DS-K1T341A Series MinMoe Terminal

Release Notes (2021-12-10)

Device Model: DS-K1T341AM DS-K1T341AMF	Firmware Version	ARM: ACS_641_AI3_EN_ STD _V3.2.30_build211122 ACS_641_AI3_EN_ NEU _V3.2.30_build211122
	SDK	Latest version
Naming Rule: M for M1 card, F for fingerprint	iVMS-4200 Client Version	Latest version baseline

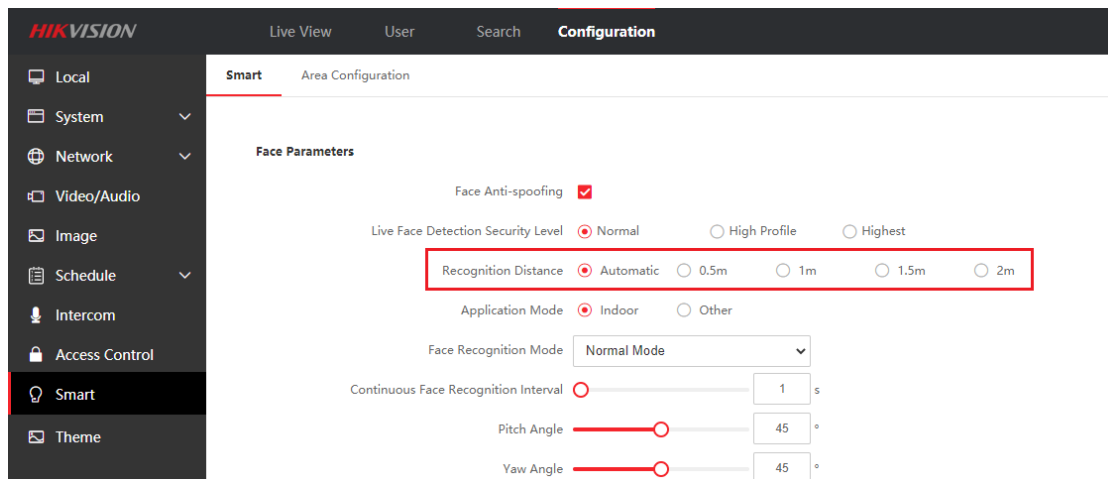
1. Add Hik-Connect menu in device UI Menu → Comm. The function is disabled in default.
